Monticello Extended Power Uprate (USNRC TAC MD8398):
Acceptance Review Supplemental Information Package 3

Non-Proprietary Version of Enclosure 1,
Mechanical and Civil Engineering Branch
Questions and Responses

Group 6

Eigenmodes of Monticello steam dryer at 25 Hz, 154 Hz and 162 Hz.

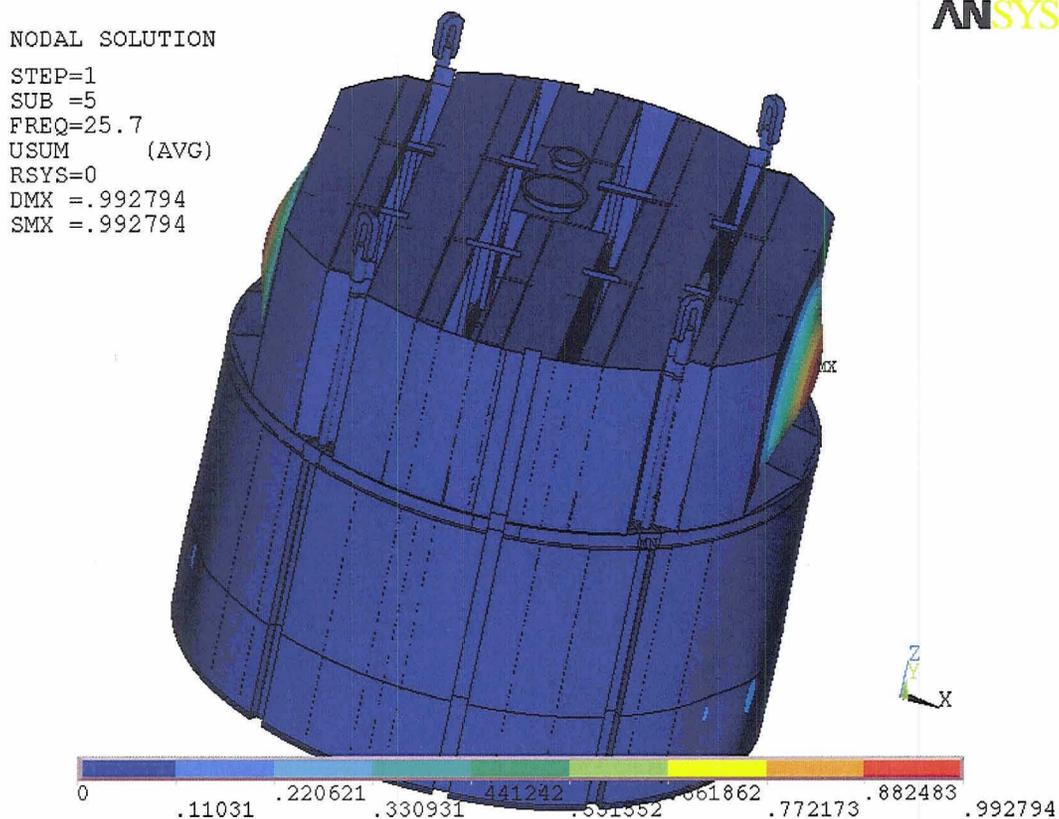
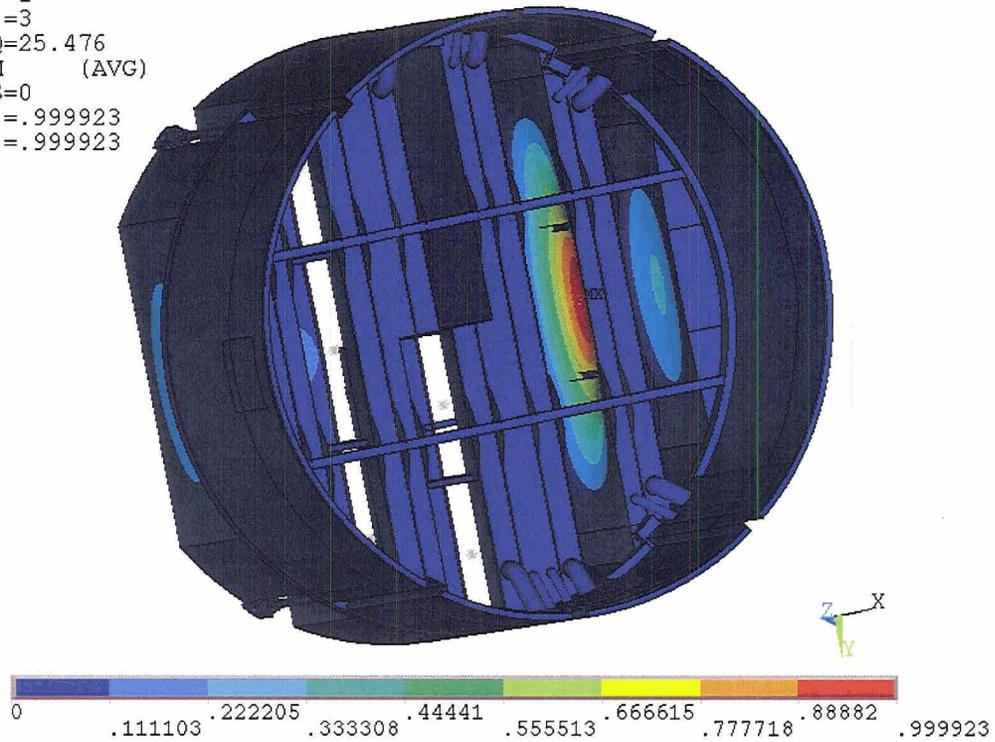
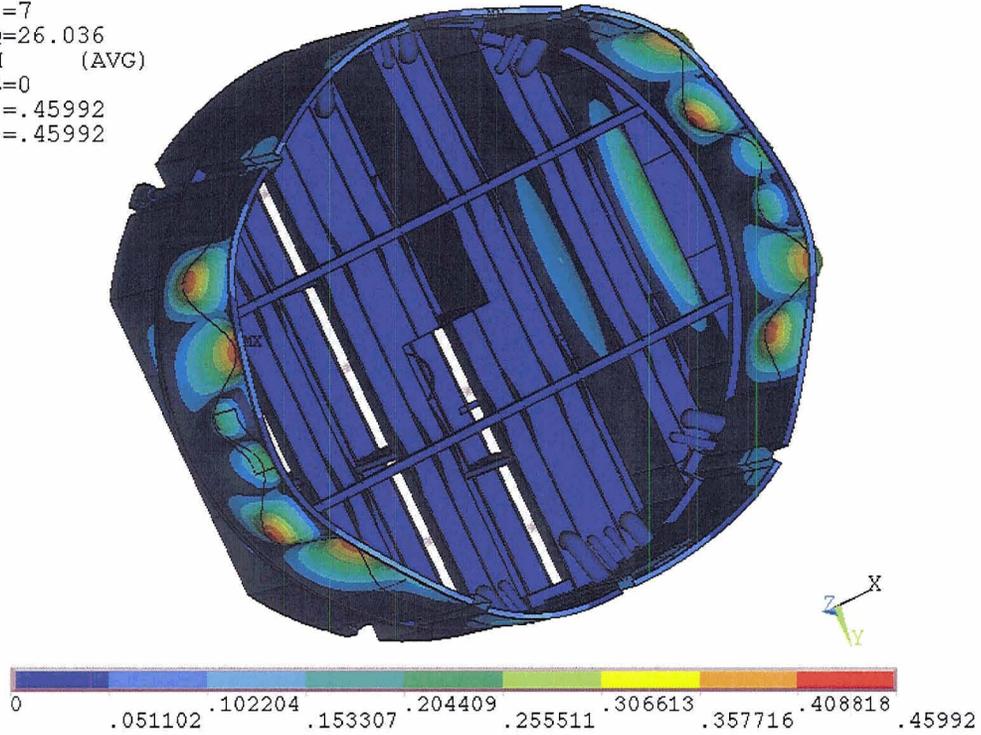
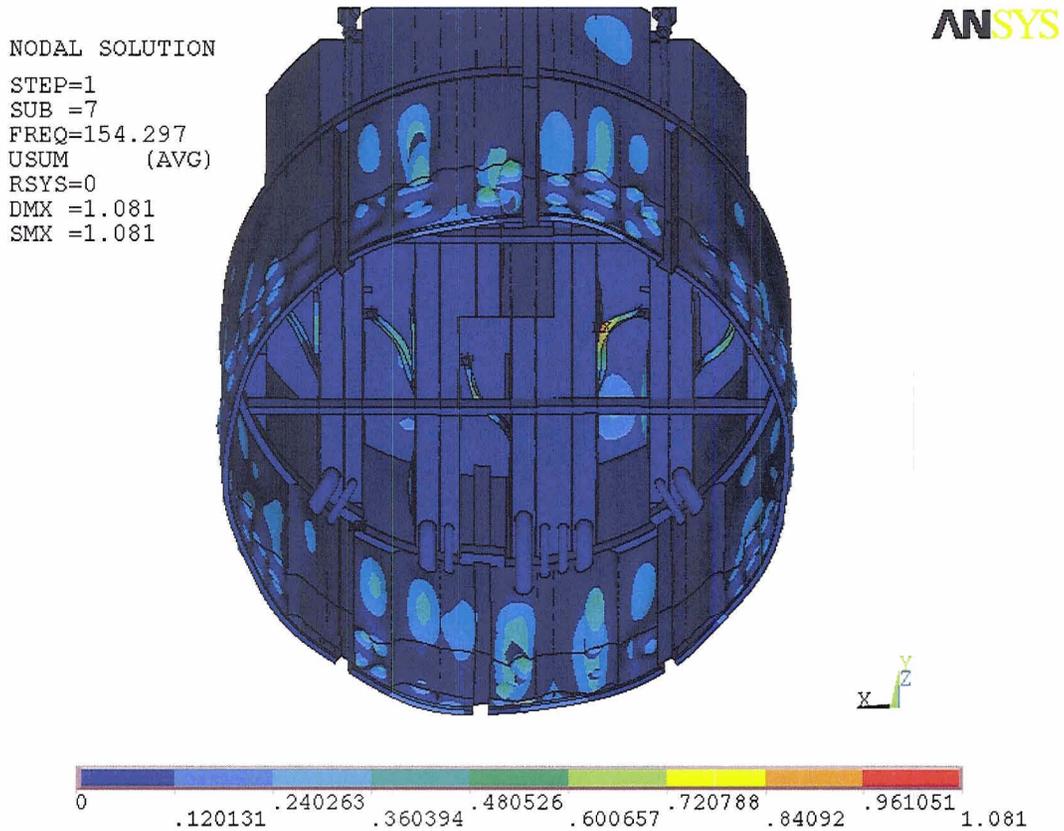
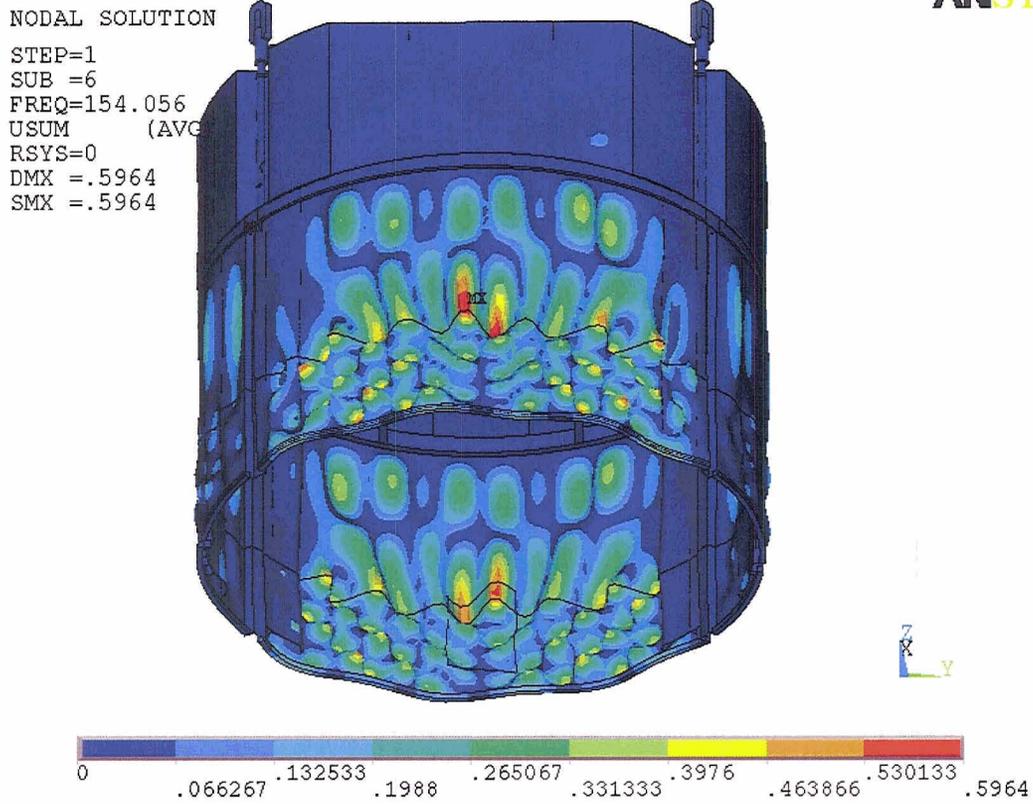
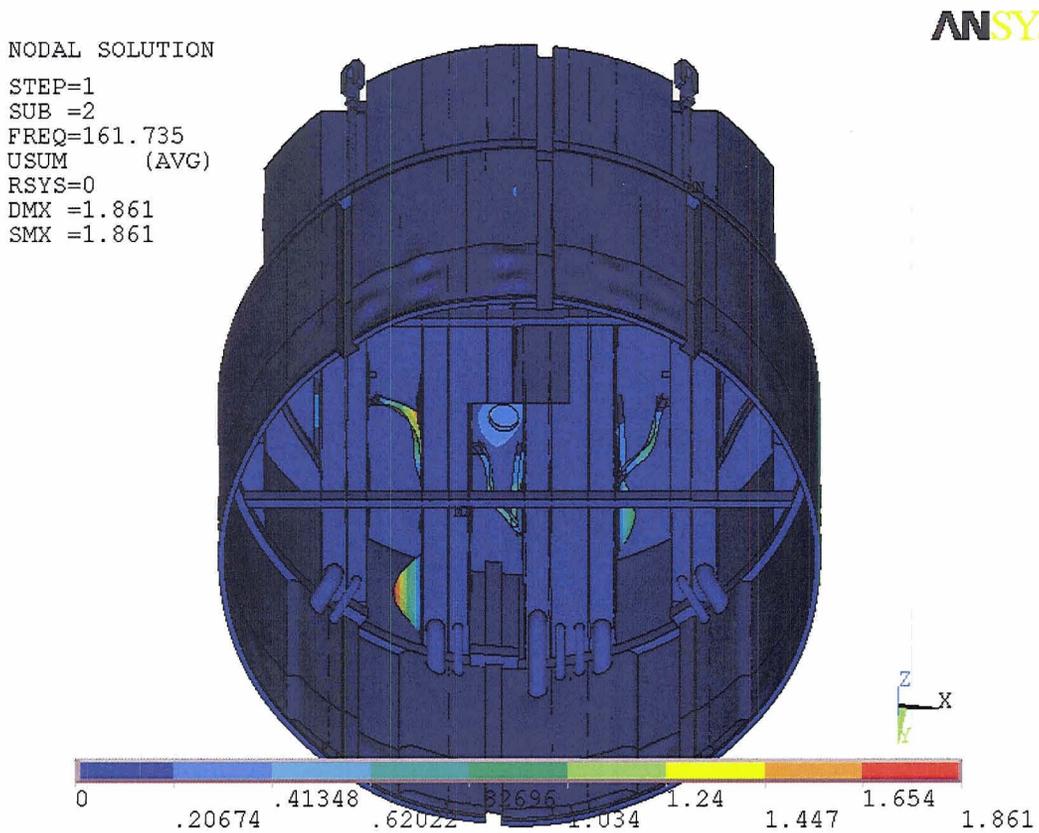
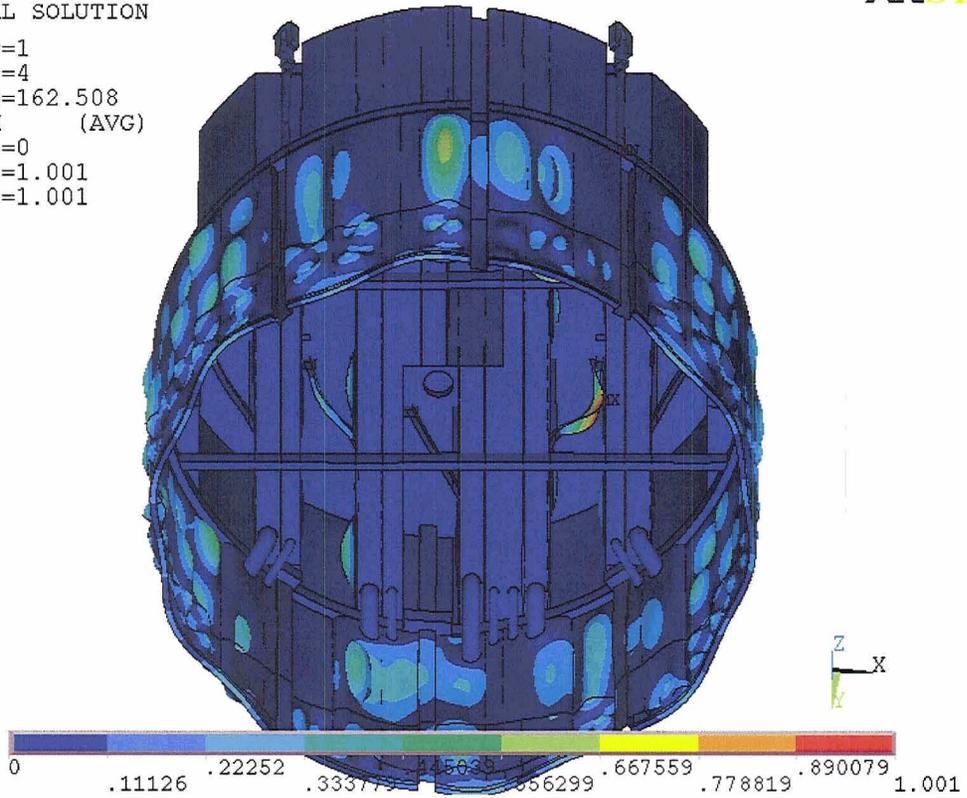
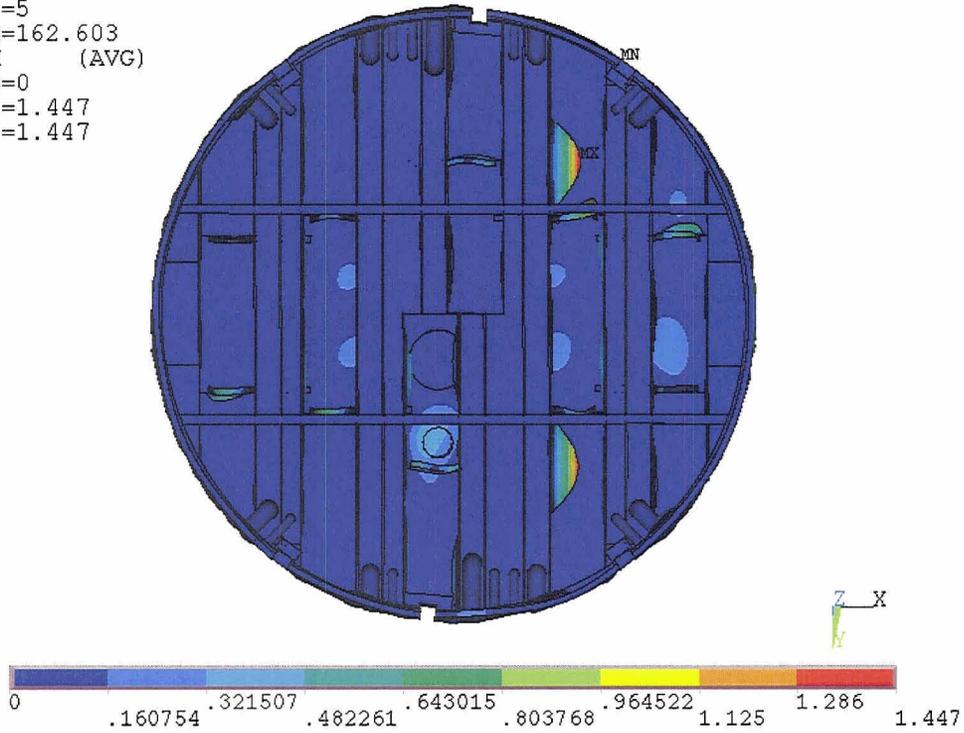
6.7: *The application does not include information on the mode shapes of the dryer at and near peak frequencies including 25-26 Hz, 154 Hz, and 162 Hz.*

Please refer to Figures 6.7a through 6.7h of this response for this information.

The modal analysis was conducted using the Monticello steam dryer model in the requested frequency ranges. Due to dryer symmetry and multiple parts having close resonant frequencies the multiple similar modes are expected. Below is a summary of the displacement shapes of dominant modes. Displacements are normalized to the mass matrix.

There are five eigenmodes in the range 25-26 Hz. These eigenmodes involve primarily hoods of the steam dryer as indicated on Figure 6.7a and Figure 6.7b. Additionally, there are modes with coupled motion of the hoods and the skirt, as shown on Figure 6.7c.

There are ten eigenmodes in the 153-155 Hz range. Most of these involve motion of the diagonal braces under the hoods, see Figure 6.7d. There is also a skirt mode, see Figure 6.7e. Other modes are various combinations of these two.

There are seven eigenmodes in the 161-163 Hz range. Most of these involve motion of the diagonal braces under the hoods, see Figure 6.7f. Also there is a mode coupled to the skirt, see Figure 6.7g. Finally, there are several modes involving the middle hoods, see Figure 6.7h. All other modes in this frequency range are essentially combinations of these three.

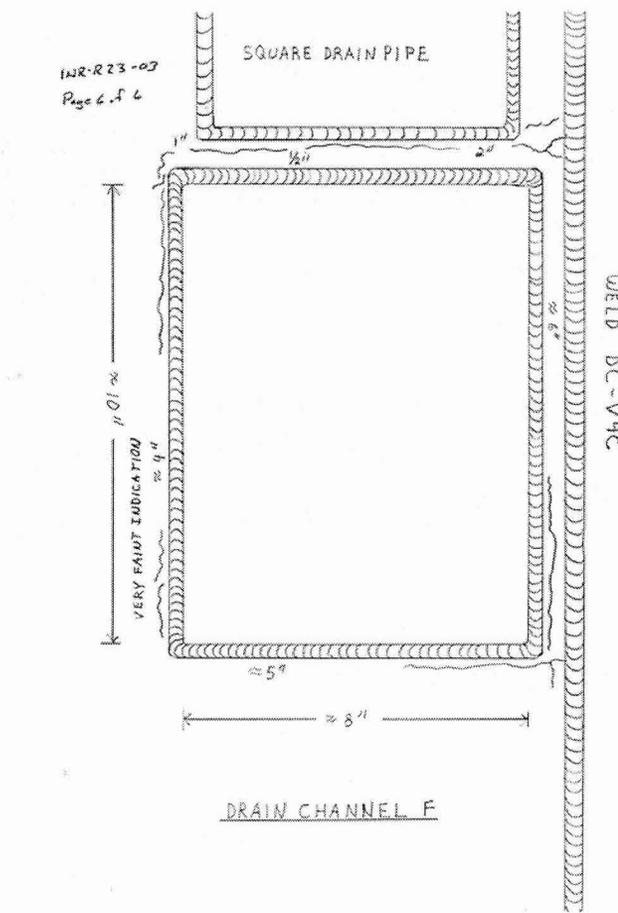
6.3: The application does not include information on operating history, location of flaws and cracks that currently exist in the steam dryer, and the root causes for such cracks. Furthermore, the application does not address the effect of EPU on the integrity of the dryer in the presence of existing cracks.

Indications at Steam Dryer Welds V3 90°, V10 90° and V10 270°:

The indications on the Monticello steam dryer are at the top of the vertical weld behind the lifting rods. Figures 5-1 and 5-3 through 5-8 of BWRVIP-139 provide weld identification numbers that were used to identify the steam dryer welds.

The stresses due to flow induced vibration (FIV) loads were qualitatively reviewed using information provided in BWRVIP-139. Typical finite element analysis (FEA) results of a square hood steam dryer design are presented in BWRVIP 139. From the FEA results, the stresses at the location of the indications due to FIV loads appear to be relatively low. Figures 4-8 and 4-9 of BWRVIP-139 show stress plots for the vertical dryer plates of a square hood steam dryer design. A review of these plots shows that the stresses due to FIV are relatively low at the location of the indications on welds V3 90°, V10 90°, and V10 270°. This is further supported by FEA results for the Monticello steam dryer as shown in Extended Power Uprate (EPU) License Amendment Request (LAR), Enclosure 11, Figures 13a, 13c, 14a, 14b, 14c and 14d. Monticello current licensed thermal power (CLTP) alternating stresses at the indication locations are below 500 psi and peak stresses are on the order of 1000 psi. These values are well within allowable stress values. Thus, high residual stresses due to fabrication were most likely the cause of the indications along with some stress concentration, rather than the magnitude of the FIV loads. This conclusion is also reinforced by the extent of cracking. The lengths of the indications are relatively short and would expect to be significantly longer at this time if significant FIV loads were present. Sufficient time has passed such that enough cycles would have occurred to cause initiation and significant crack growth if the FIV loading was significant.

Based on available information, the Monticello steam dryer indications at Welds V3 90°, V10 90°, and V10 270° were fabricated using the same welding sequence resulting in elevated residual stresses. After the crack initiated, the residual stress would be reduced as the crack extended and the crack growth would slow, limiting the length of the indication. Since loads in this area based on the Monticello FEA are low, crack growth is not expected under EPU conditions.
